REMARKS

Application No.: 10/763,333
Art Unit 2879

Attorney Docket No. 0630-1942P
Reply to September 7, 2005 Office Action
Page 23

FIG. 6

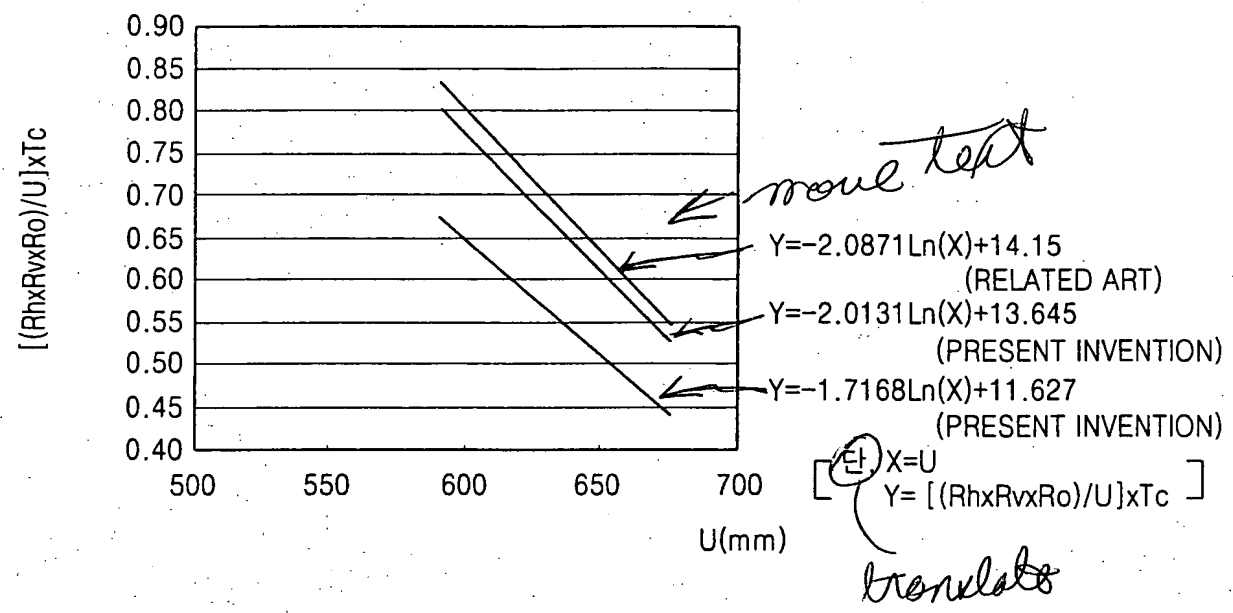
The Examiner has objected to the drawings because the plotted line that corresponds to each of the shown equations is not distinguishable because the style of the lines is identical.

The legends currently located outside of the graphs have been moved inside of the graphs adjacent to the plots, which illustrate the legends. In this way, one legend is clearly associated with one plot. Also, the Kenji character found in the legend of each of Figs. 6-12 has been translated.

FIG. 8

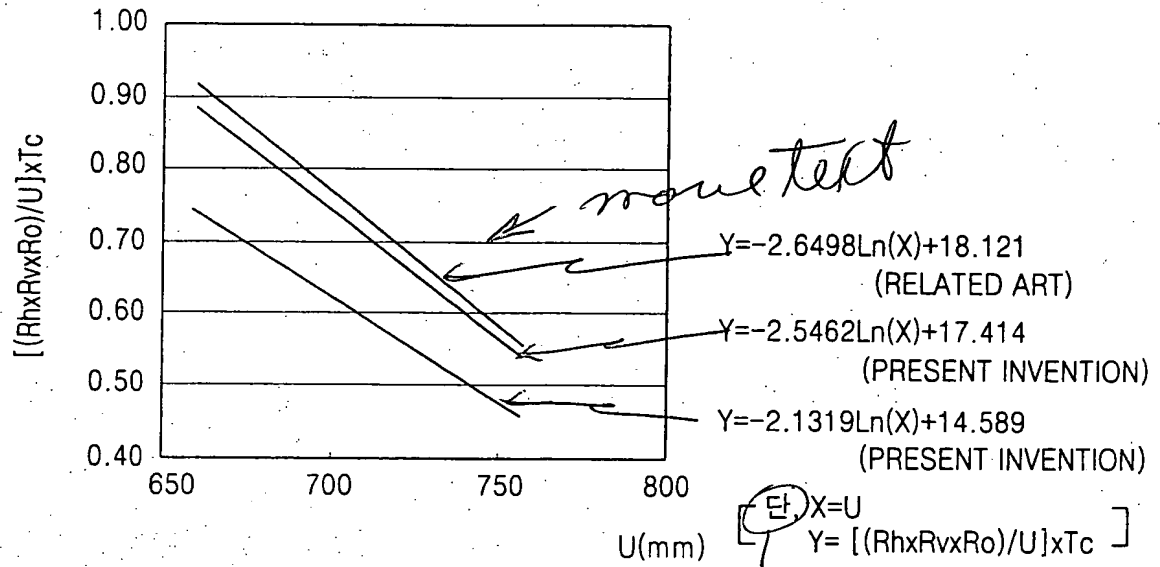
translate
